## Sandleford Park, Newbury

### APP/36: Lee Witts' rebuttal to Jon Bowden's Proof of Evidence

21<sup>st</sup> April 2021

Review of JBA Ground Water  
Mapping against Site Topography  
Page 1 of 4

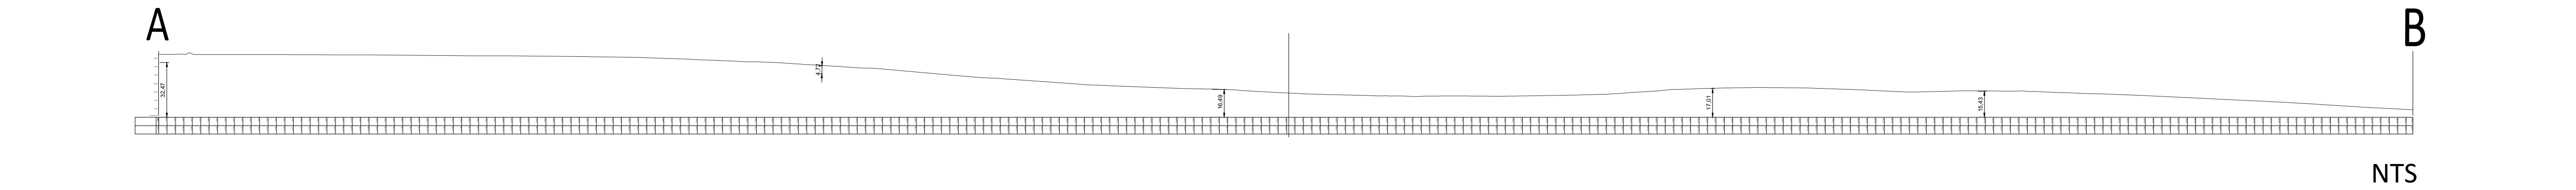
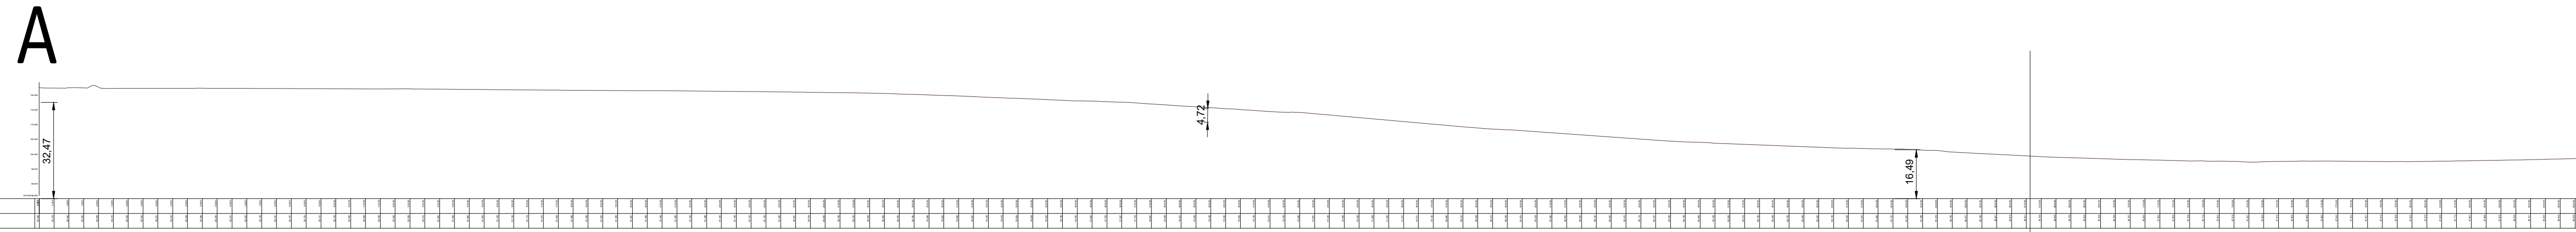
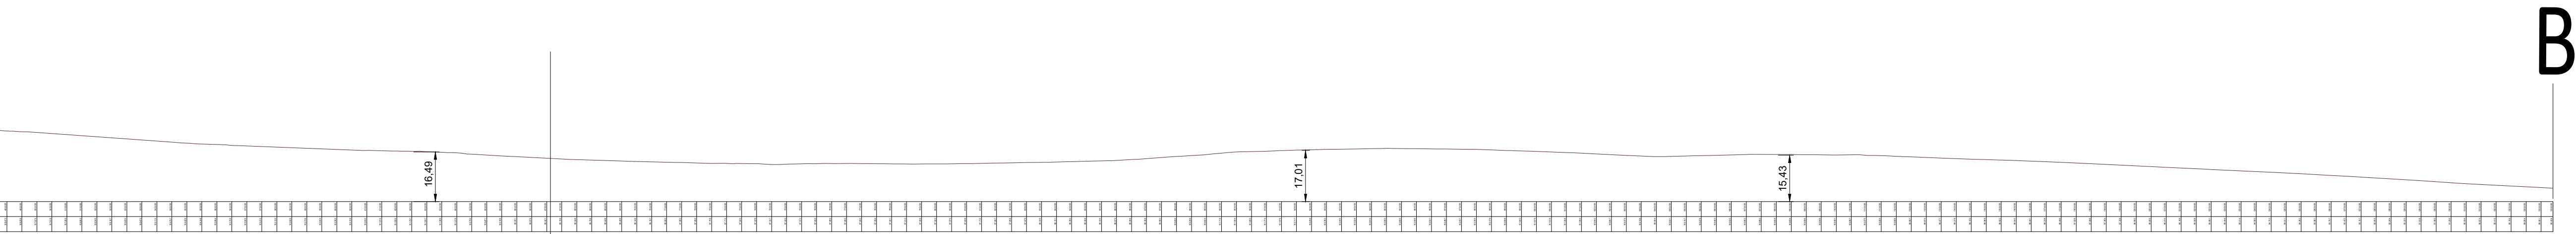
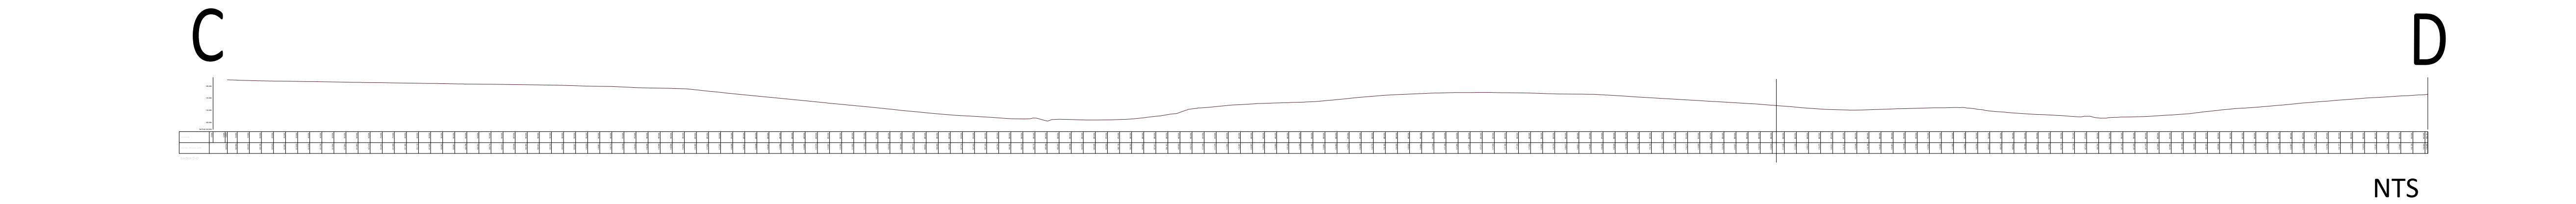
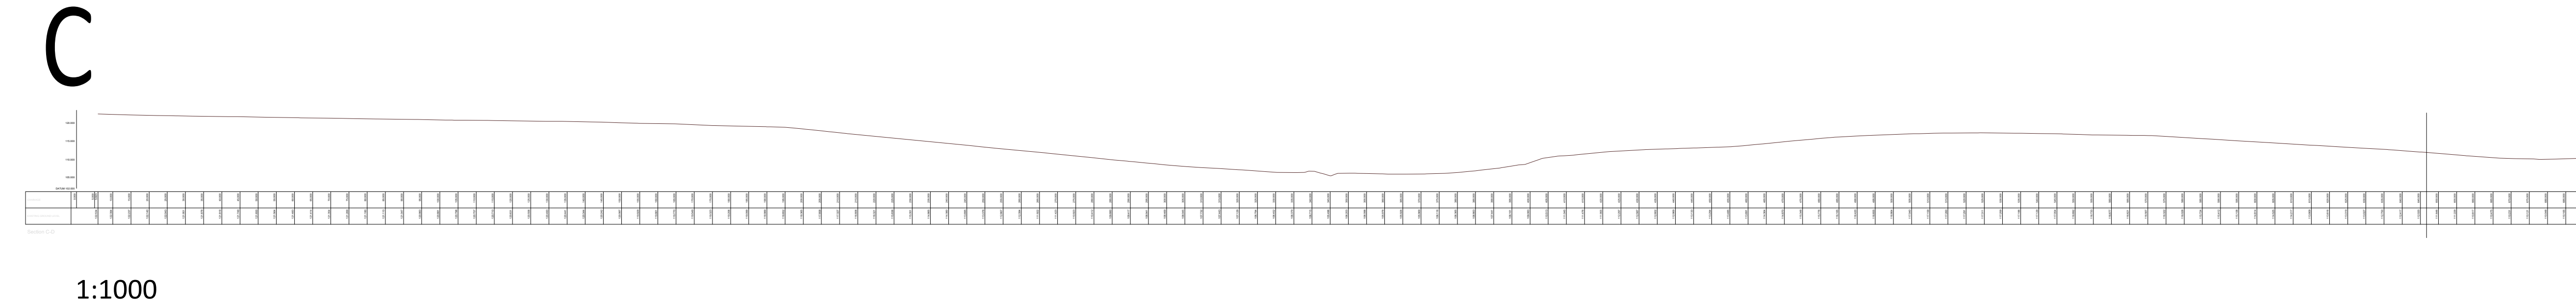
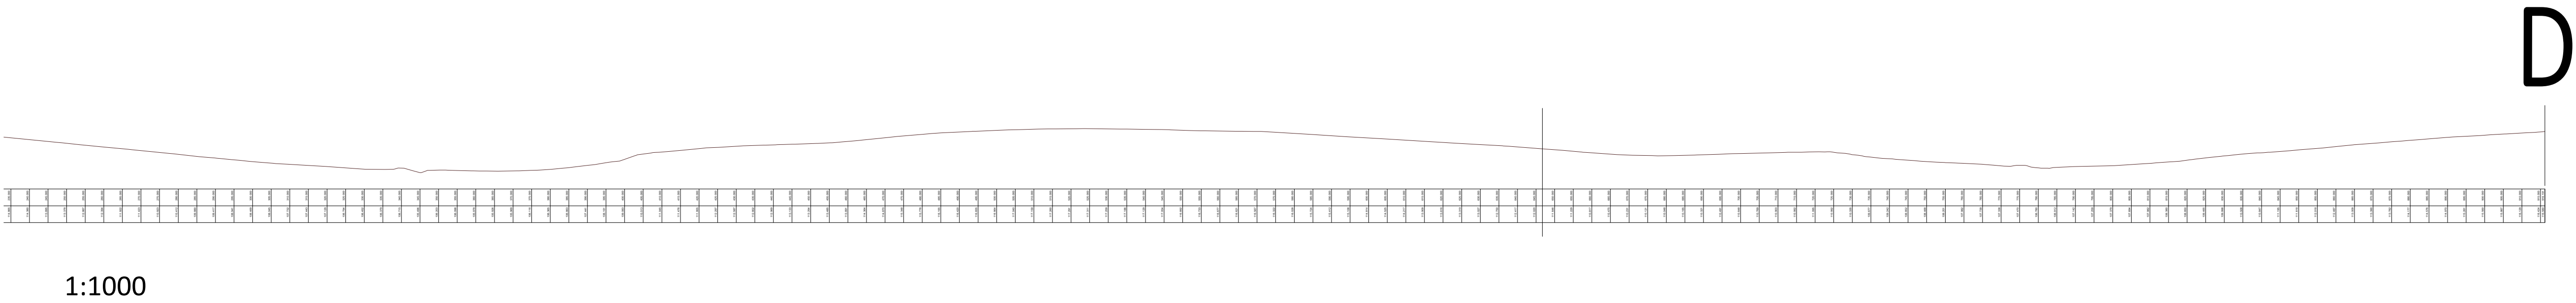
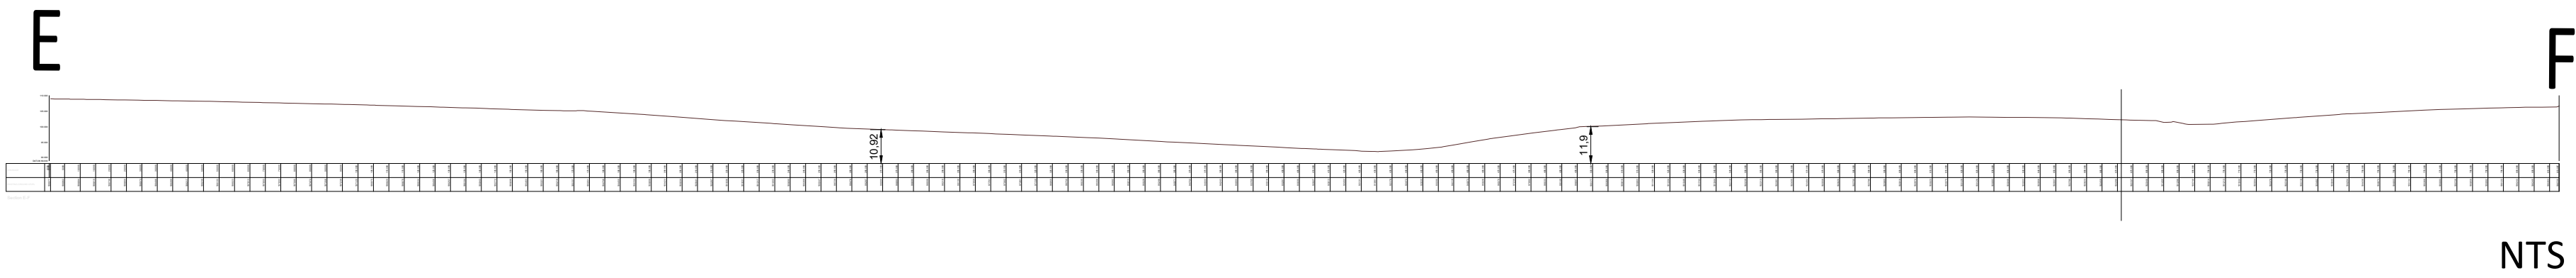
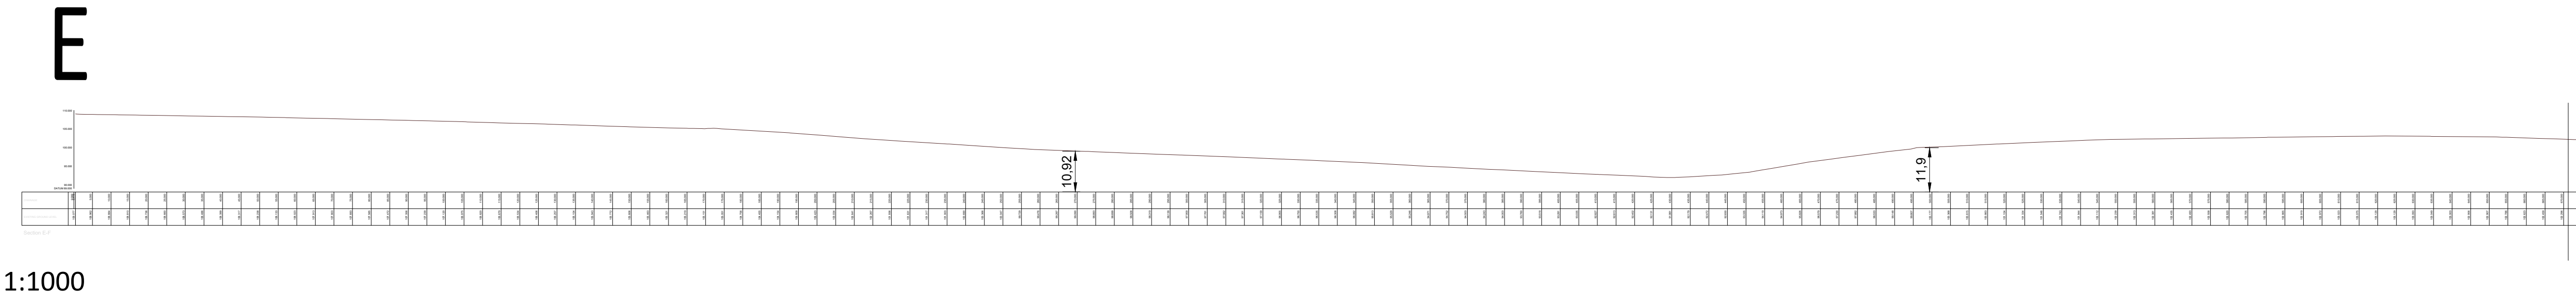
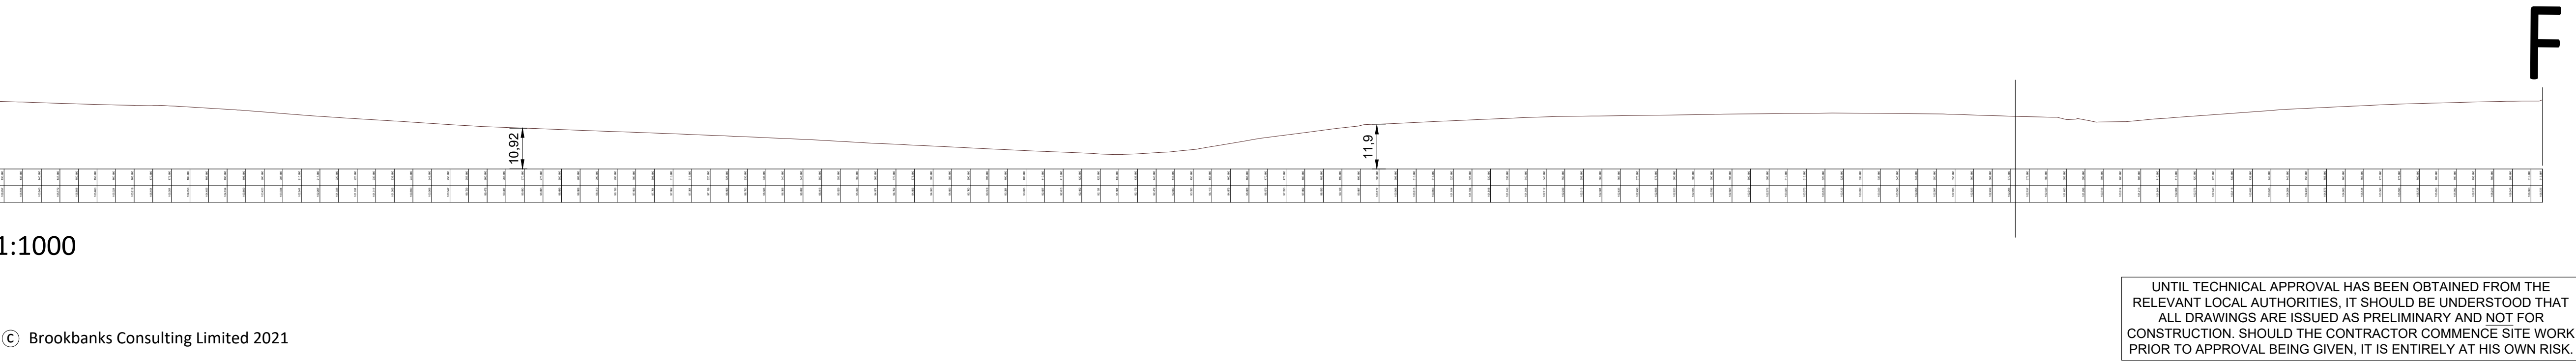
- 1.21 I consider the JBA mapping to be illogical and inconsistent with how groundwater would behave within this site, taking account of topography, geology and the intrusive site investigation. To visually demonstrate these inconsistencies, a series of drawings have been produced in order to compare the ground water levels indicated by JBA's map in relation to the topography of the site. The drawings have been provided within the Appendix of this note, being:

**Appendix A** – Review of Ground Water Mapping against Site Topography  
**Appendix B** – Review of Ground Water Mapping against Original Drainage Strategy  
**Appendix C** – Review of Ground Water Mapping against Alternative Drainage Strategy 1  
**Appendix D** – Review of Ground Water Mapping against Alternative Drainage Strategy 2
- 1.22 Firstly, groundwater does not slope parallel to the topography of the surface. Groundwater can only drop abruptly in the presence of a geological fault. However, there is no evidence that there is such a fault that occurs within the site boundary. Because of this there will not be such an immediate and dramatic change in groundwater levels due to a change in geology. The levels will rise or fall gradually across the site.
